Columbia River Crossing

Testimony by Tom Bender * 12 Feb. 2014

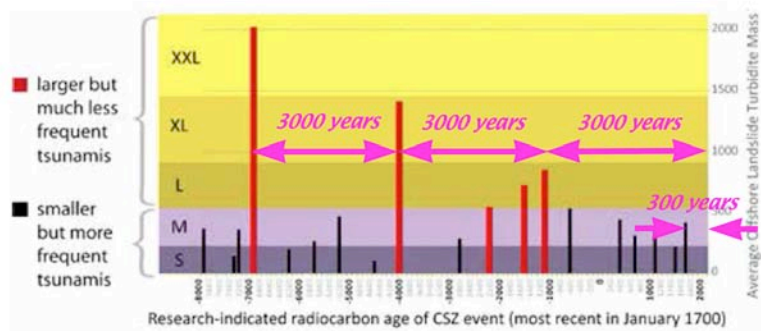
However, the 2012 Tsunami Inundation Maps for Tillamook County, etc. now show a runup to +80' rather than +40' as before. This is based on discovery of a pattern of extremely more powerful mega-earthquakes occurring every 3000 years. (See graphic below, from the TIM - purple arrows added by me). It's been, of course, 3000 years since the last one.

The issue for the CRC is that it is apparently designed from current building code standards, and therefore would unlikely survive one of these mega-quakes. It doesn't appear prudent to me to invest billions in a new bridge for security and not have it designed to survive and provide that security.

- EVALUATE seismic capabilities of I-5 and I-205 bridges to see their capabilities, upgradeability, and whether a new seismic-safe bridge is needed.
- RE-ENGINEERING - revision of the proposed CAC bridge design to have strength to meet the newly understood seismic needs.
- PHASING - Construction of ONE of the two bridges in the project ASAP, to reach affordable costs and seismic security needs.
- CONTINUED USE OF EXISTING SPANS for one-direction motor vehicle traffic, pedestrians, transit - whatever doesn't fit in one-bridge's capacity.
- REVIEW of traffic needs, financing payoff, actual toll revenues over time to determine when/if to construct second bridge.
- Other than this, I SUPPORT ABANDONMENT of the project, as the information from 1000 Friends of Oregon on reduced traffic flow, etc. show little if any need for the project.
